SERVICE BULLETIN

Service Bulletin No.: DAC1-92-03, Rev. 0

Title: Certification, Mexican Import Requirements

Figure 1
Exterior Canopy Placards Installation

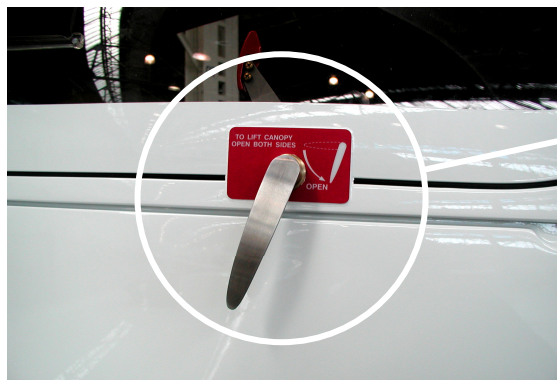
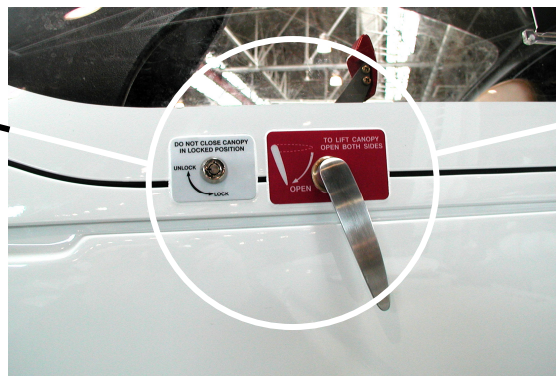
- 10.1** Replace the English language placards with the Spanish language placards as shown in Figures 1 through 5. Refer to Aircraft Maintenance Manual DA201-C1 for the instructions to remove and re-install the canopy lock and canopy handles.

22-1120-03-20

22-1120-03-01

22-1120-03-19

Figure 2
Interior Canopy Placards Installation

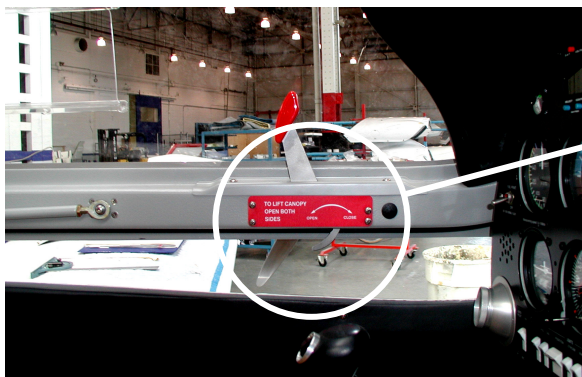
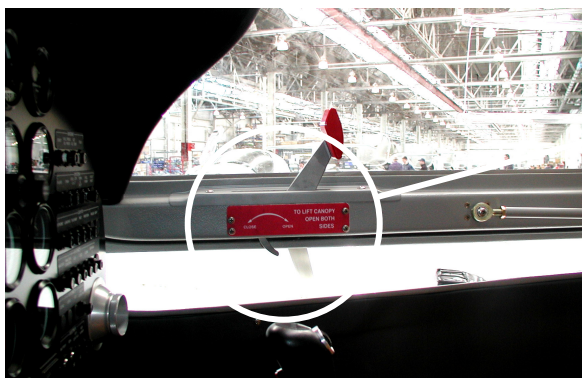
22-1130-03-31

22-1130-03-32

Figure 4
Rescue Hammer Placard Installation

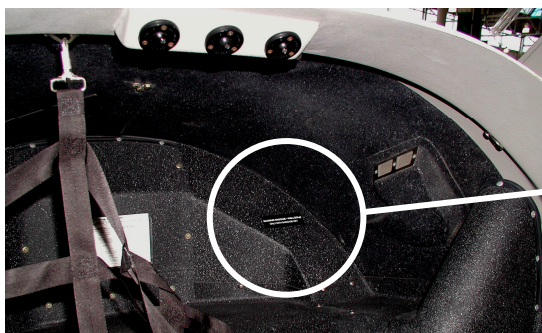
22-1130-03-05
